**HISTORIC PRESERVATION REVIEW BOARD
STAFF REPORT AND RECOMMENDATION**

Landmark/District:	Mount Vernon Triangle Historic District	(X) Agenda
Address:	923-925 5th Street NW	() Consent
		(X) Concept
Meeting Date:	March 25, 2021	(X) Alteration
Case Number:	21-056	(X) New Construction
		() Demolition

Kline Operations, working with architect Peter Fillat, seeks on-going conceptual design review for construction of an 11-story condominium building with ground level retail that incorporates the historic facade of 925 5th Street.

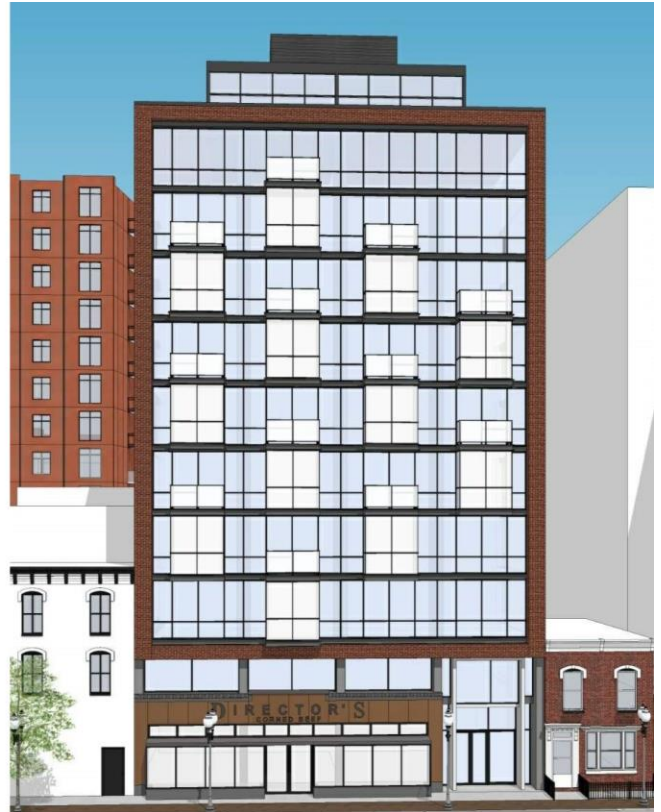
The revised scheme includes several refinements. The most successful revision is the addition of the strong brick border along the 2nd floor which helps frame the upper floors, setting it apart from the first floor, and also creating a strong datum line with the surrounding 2-story brick buildings. On the side elevations, brick has been introduced between the windows on each floor to break down the scale of the multi-story slot windows.

On the front elevation the architect prepared numerous studies of the size, location, and number of bays. This revised scheme reduces the depth of the bays from 4' to 3', and slightly changes the composition of the bay pattern from the previous submission.

The revised scheme results in modest improvements, creating a stronger sense of base and separation of the historic façade from the tower above. However, many of the Board's comments from the December 2020 review remain unaddressed and it was HPO's understanding that the Board was looking for a more fundamental rethinking of the design to improve its compatibility with the Mount Vernon Triangle Historic District. HPO seeks the Board's guidance as to whether the revised concept is sufficient in addressing its concerns, or whether a more fundamental redesign is required.

Regardless of the direction of the design, the applicant should also include information in the permit submission as to how the polychrome panels will be removed, protected, and cleaned, and continue to work with the HPO's archaeologist to complete the archaeological survey required on this site.
